FIPC BASIC FORM						
PROCEDURE: HI - VOR Z OR TACAN RWY 21 AMDT 3			AIRPORT NAME: SAN ANGELO RGNL/MATHIS FLD		AIRPORT ID: KSJT	SPECIAL CONTROL NO: OP-01-075-26
FAC ID: SJT		CITY: SAN ANGELO			ST: TX	ORIG CHART DATE: 05/14/2026
DFL TYPE: PROC/A	THIRD PARTY: ☐ YES	EST. TIME ON SITE: 0.4	REIMB. NUMBER:	PTS TASK ID: EDF7685C90784D4F9F56B651B5E79A16		
PREFLIGHT NOTES						
REVIEWER:					DATE:	
COMMENTS:					CHECK ONE: ☐ FLT CK REQ ☐ NFCR ☐ REJECT	
						YES
					CPV COMPLETE?	
					X	
PROCEDURE RESULTS						
INSPECTION DATE: 02/03/2026	CREW #: VN330	N #: N68	INSTRUMENT PROCEDURE STATUS: ☒ SAT ☐ SAT W/CHANGES ☐ UNSAT		ARINC CODING: ☐ SAT ☐ SAT/GOLD ☐ UNSAT	
FLIGHT INSPECTOR SIGNATURE: brian harrelson @ 02/03/2026 20:53			PRINTED NAME: HARRELSON, BRIAN DAVID			NOTAM INITIATED? ☐ YES ☒ NO
FLIGHT INSPECTOR REMARKS: Complete/SAT.						
IN-FLIGHT OBSTACLE REPORT						
OBSTRUCTION ID #:	COORDINATES OR LOCATION:	GNSS ALTITUDE (MSL):	BAROMETRIC ALTITUDE (MSL):	HEIGHT ABOVE GROUND LEVEL:

HI-VOR Z or TACAN RWY 21

SAN ANGELO RGNL/MATHIS FLD (KSJT)

Subject: Approval Request: SAN ANGELO RGNL/MATHIS FLD, SAN ANGELO, TX, (SJT) HI-VOR Z OR TACAN RWY 21

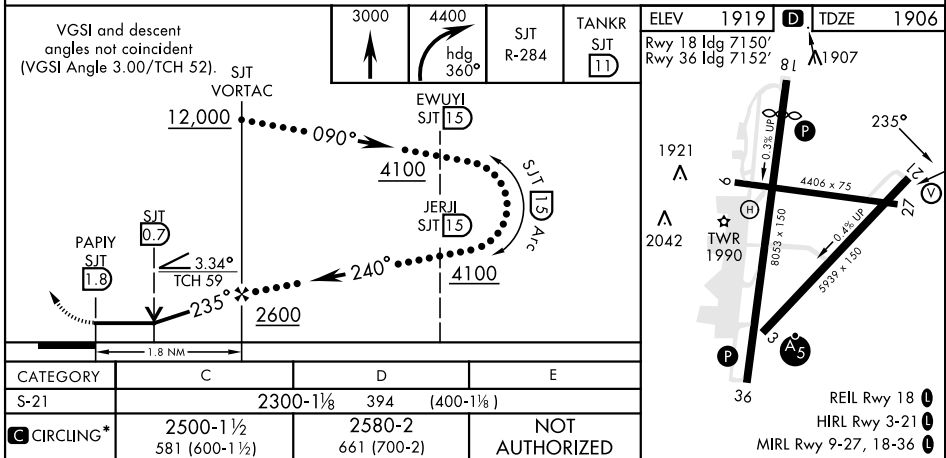
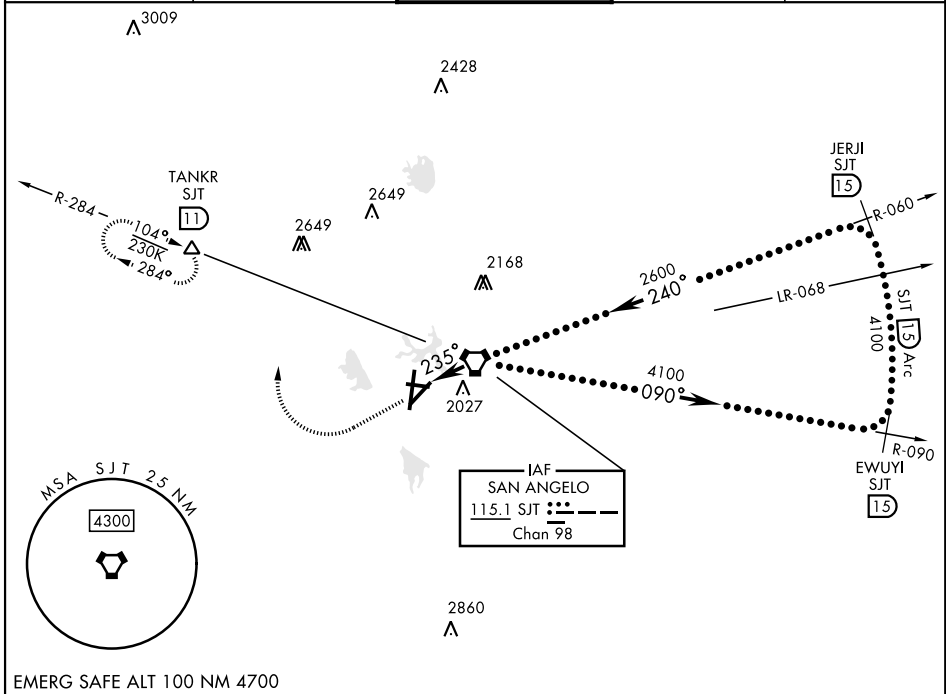
FAAO 8260.3G, para 2-6-2a. Glidepath Angle (GPA) and Vertical Descent Angle (VDA). Flight Standards approval is required to establish a VDA (of a procedure where the FAC is straight-in aligned) that is more than 0.20 degrees greater than the glidepath angle of a VGSI installed to the same runway.

The HI-VOR Z OR TACAN RWY 21 procedure is a Cat C-E non-precision straight-in aligned approach with GPA of 3.34° and TCH of 59. TCH for procedure meets the minimum glidepath-to-wheel height for height group 4. The VGSI for Rwy 21 is aimed at 3.00 degrees and TCH of 52. Decreasing the procedure GPA to match the VGSI angle of 3.00 degrees would not be desired by the military users. The procedure will publish the following chart note: VGSI AND DESCENT ANGLES NOT COINCIDENT (VGSI ANGLE 3.00/ TCH 52). VDA is currently published and will remain published on the procedure.

The airport requests continuation of the higher GPA to accommodate military training flights that frequently use this procedure. Request approval to use the 3.34° GPA for the HI-VOR Z OR TACAN RWY 21. There are no future plans to change the GPA to match the VGSI angle. If approval for non-coincidence is not granted, military training flights from KRND and KDLF would be negatively impacted. There are no obstacles that penetrate the 20:1 surface.
